STAFF REPORT: 04-14-2021 MEETING PREPARED BY: A. DYE

APPLICATION NUMBER: 21-7155 **ADDRESS**: 4100 THIRD AVENUE

HISTORIC DISTRICT: WILLIS-SELDEN

SCOPE: NEW HVAC EQUIPMENT ON ROOF; ADD DOORWAY ON REAR

A1-01 Roof Plan

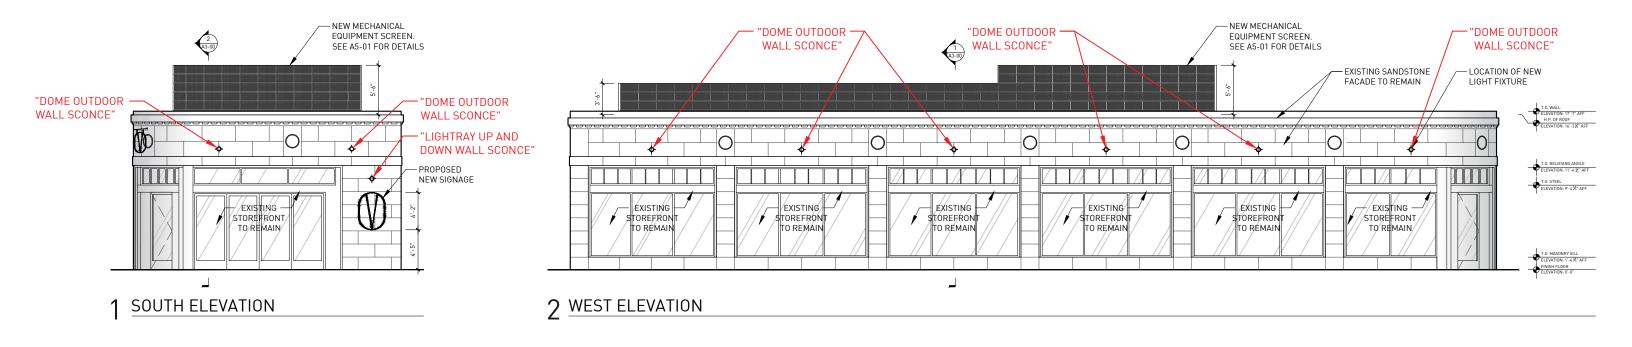
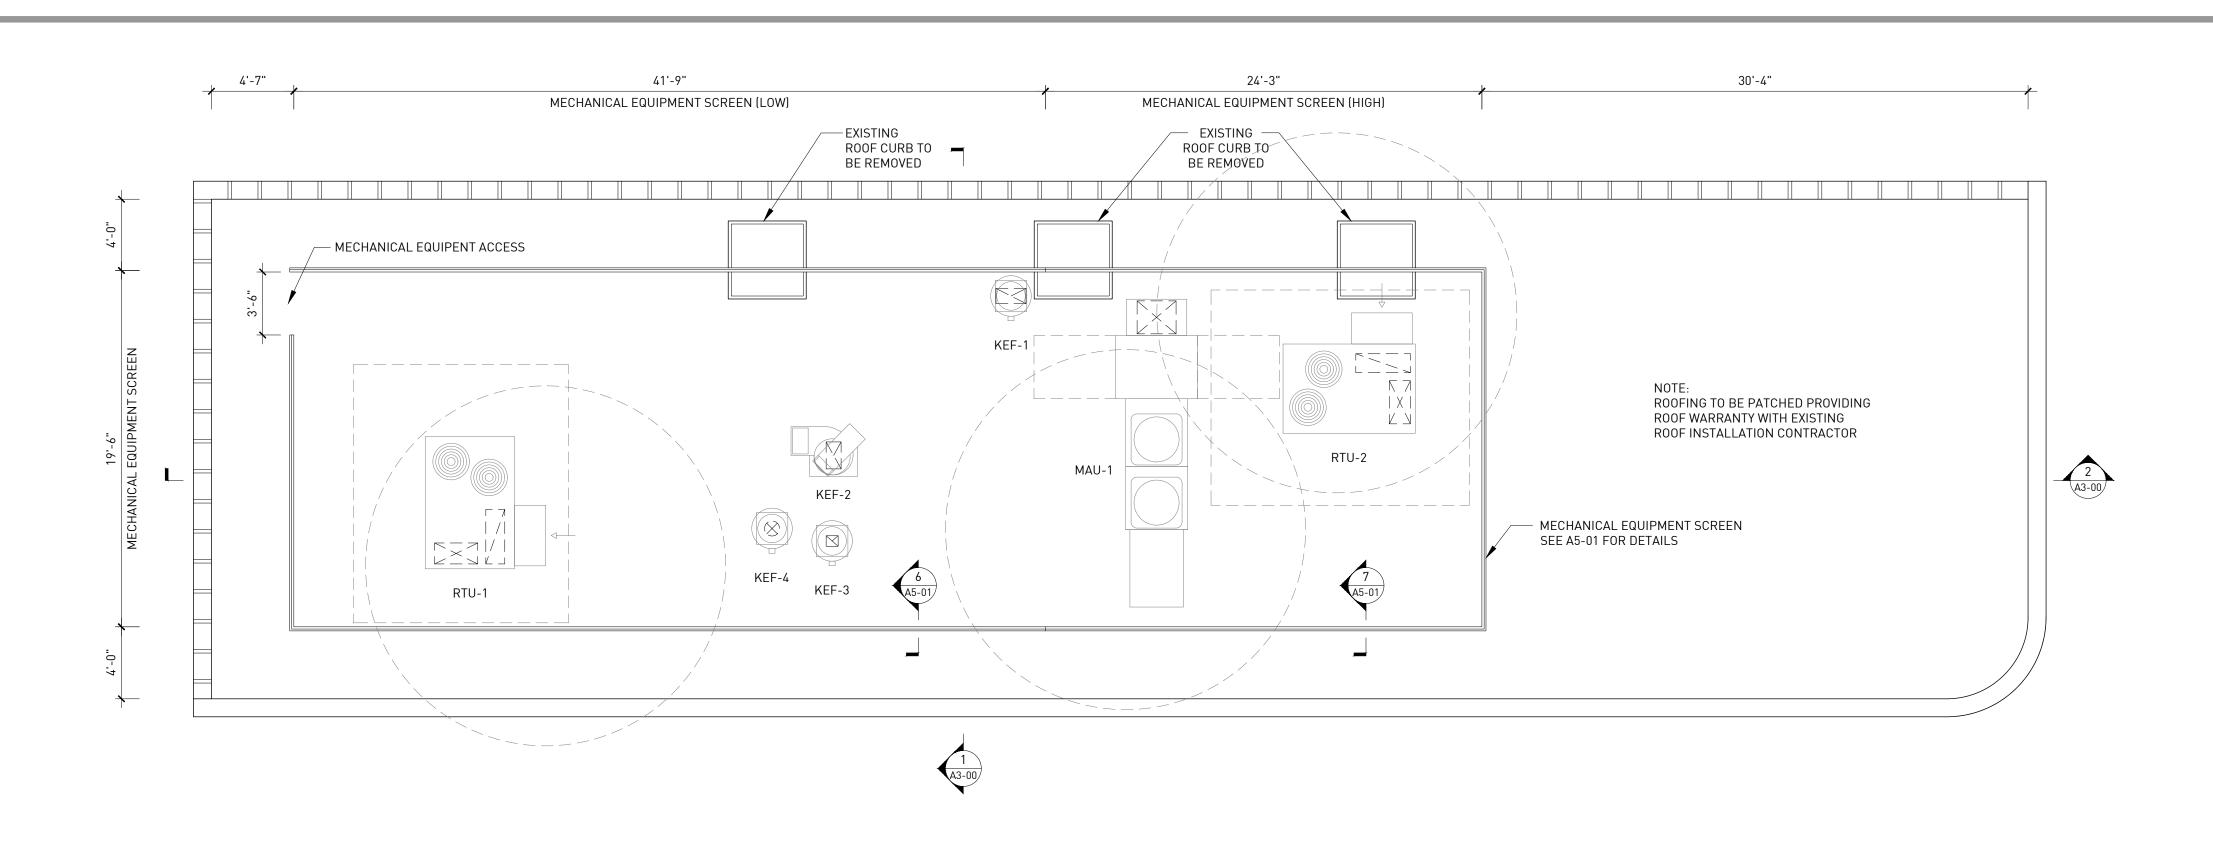
- The distinctive character-defining features of this building are the minimally designed classic details, its simplicity of form, low horizontal massing and smooth surfaces. Installing an equipment enclosure on the roof introduces color, pattern, and verticality to the structure and a dominant massing which counters the tenents of the historical design and horizontality of the building. It is staff's opinion the equipment will be less intrusive if installed with no screening as this would allow for visual breaks between the equipment, minimizing its visual mass.

PROPOSED ELEVATIONS

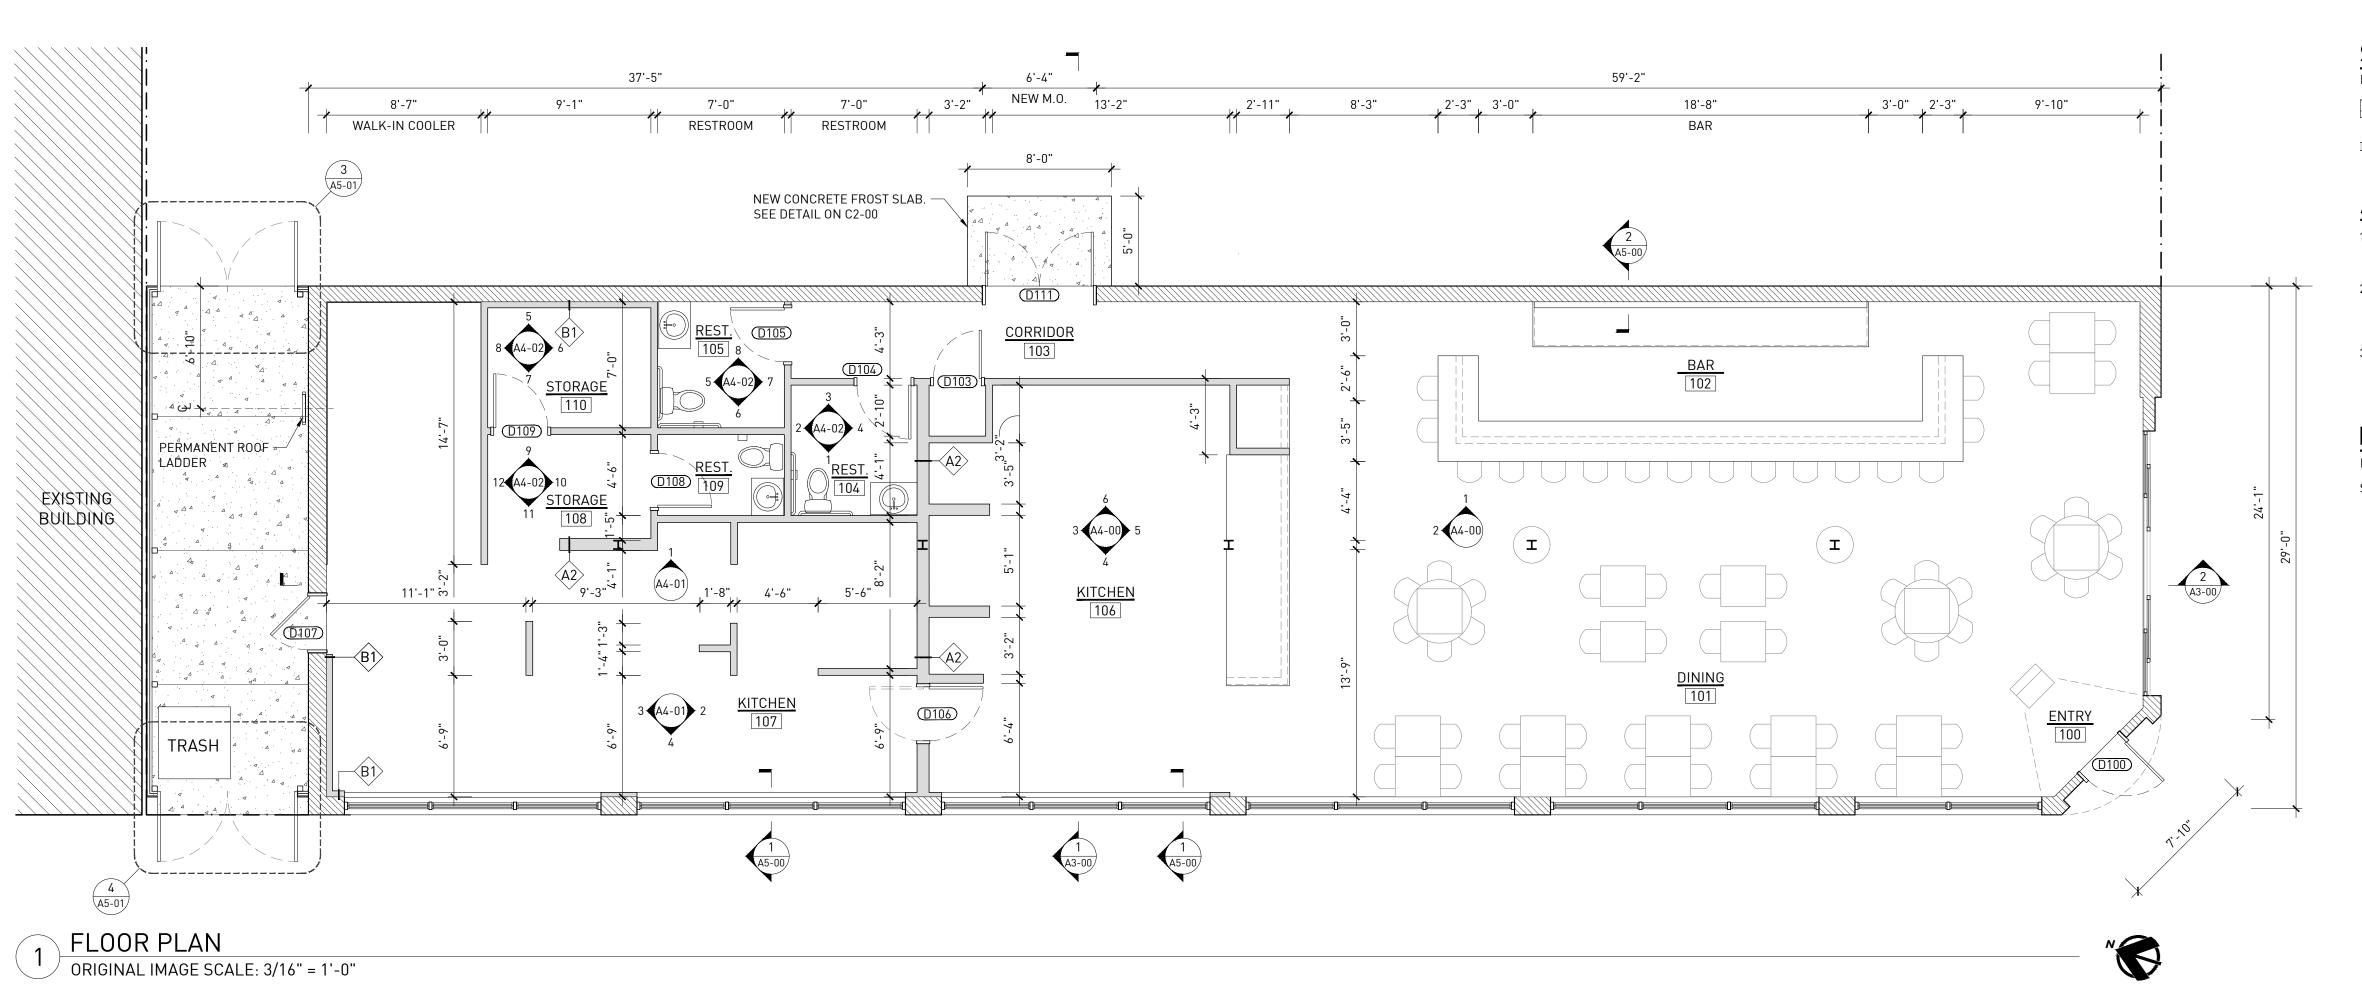
- <u>Updated 4/14</u>: The placement of the up-down light on W. Alexandrine (directly above the wall-mounted sign) will require a new junction box. The revised elevations only note locations of the lights and do not show how the elevations will look with the lights installed, drawn to scale. Staff wonders if the light cast from the up-down fixture will offer enough lighting (as the adjacent dome light will spread to this area) to make the "cost" (i.e., hole drilled into an intact limestone panel) worthwhile. As the sign over the door will be subtly illuminated by adjacent dome lights, might the wall sign be illuminated in the same way?
